Product Support Bulletin 2004-006

Maintenance of Way ~ Work Equipment Bulletin

SUBJECT: 46690015 RH Sliding Jaw Bushing Replacement

MACHINE MODEL(S): Anchor Applicator Model E & F

Figure 1

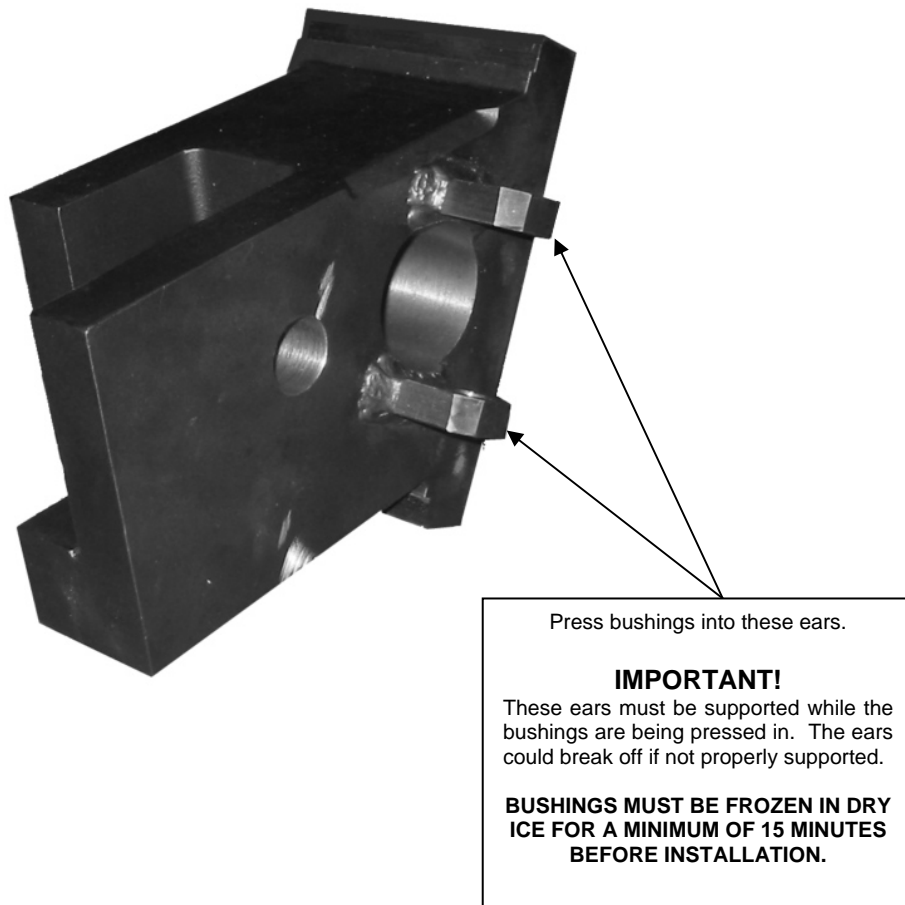
SUMMARY: The ID of the cylinder **Clevis Pin Bushings**, used with the **RH Sliding Jaw, p/n 46690015**, may be oversized. The bushings should be replaced with new bushing with a smaller ID, **p/n 22080565**. The LH Sliding Jaw, p/n 46690016, does not have bushings and is not affected by this bulletin.

OPERATIONAL IMPACT: The excess clearance between the bushings and cylinder clevis pin will cause excessive movement and could cause the clevis pin to bend or break. This will eventually damage the **Boxing Cylinder, p/n 28550024**.

ACTION: The bushings are a press fit into the Sliding Jaw. The bushings **MUST** be frozen in dry ice for at least 15 minutes prior to installation. The sliding jaw ears **MUST** be supported while the bushings are being installed to prevent bending or breaking off the ears. See Figure 1. If the bushing holes in the sliding jaw are worn, the sliding jaw must be replaced or the holes must be filled and re-bored before bushing installation. Contact the Nordco Service Department for assistance.
